Burnaby Southeast Bikeway (SEB) and Cariboo Bikeway (CB) Assessment

The Burnaby Local Committee of HUB Cycling conducted an assessment ride of the Southeast Bikeway (SEB) and the Cariboo Bikeway (CB) on Saturday, 30 March 2024.

Figure: Rendering of proposed improvements to the Frances-Union Bikeway. Source: www.burnaby.ca

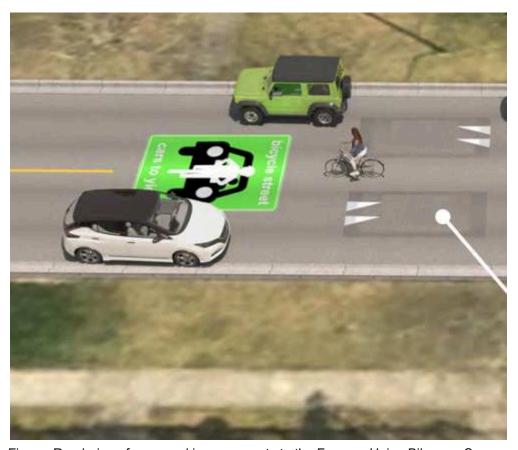
Many parts of the SEB could benefit from the bike-route road marking proposed for Frances/Union St. (rendering shown below) to reduce conflicts between people driving and people biking on the often narrow road between parked cars on either side.
